PUBLIC UTILITIES COMMISSION

Re: Data Request #24 for the SCE Ivanpah-Control (I-C) Project (A.19-07-015)

Crater Mountain Realignment Alternative: REVISED

Detail of Revised Crater Mountain Alternative – to Avoid the WSA

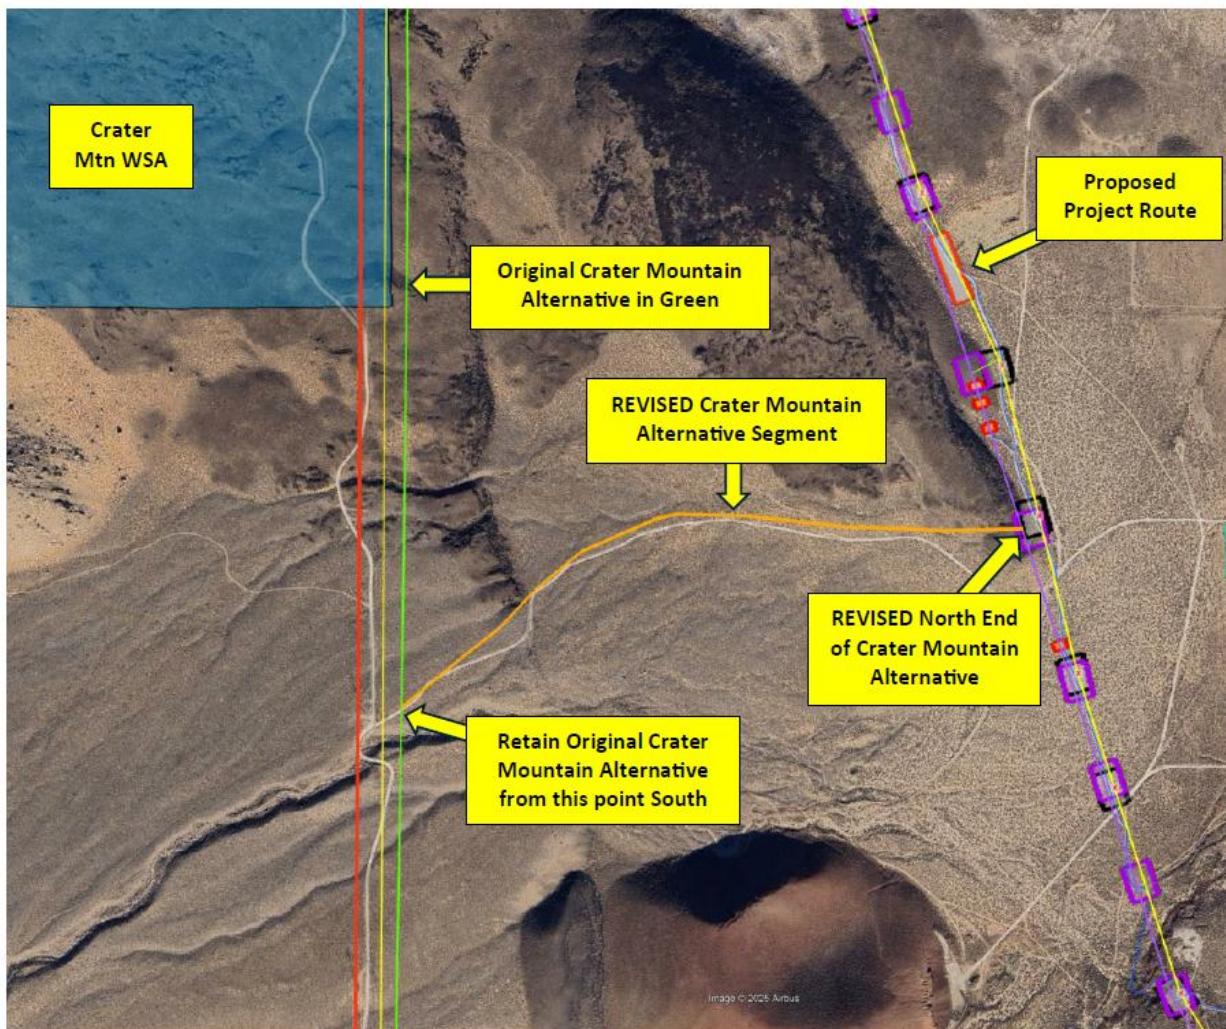
The BLM has identified that a portion of the Crater Mountain Alternative and/or its access road would be within the Crater Mountain Wilderness Study Area (WSA), which is not permittable. We have identified a potential revision to the alternative that would avoid the WSA. It appears that the two parcels that would be crossed by the revised alternative segment are owned by LADWP. Please see **Attachment A** to this letter. This revision would:

- **Retain** the southernmost 15.6 miles (of the original 18 miles) of the alternative. The southern endpoint is at approximately Structure 279 (this is also the northern end of the Manzanar Alternative).
- **Eliminate** the northernmost 2.4 miles of the Crater Mountain Alternative (the part that would be adjacent to or within the WSA), and reconnect with the Existing/Proposed route south of the WSA at Proposed Structure 190. This connection would require a new ROW of approximately 0.7 miles (4-5 structures) along an existing LADWP access road and entirely on LADWP land.

1. Please review this revised alternative and let us know if it would be feasible from an engineering and land ownership perspective.
2. Both the Proposed Project and the current Crater Mountain Alternative have been surveyed for biological and cultural resources with some buffer around each right-of-way. Please let us know how much of this short stretch of new ROW is not covered by completed surveys.

4 or 5 new structures to be located along the existing LADWP access road (orange line below)

Land Crossed by Revised Crater Mountain Alternative: LADWP-Owned
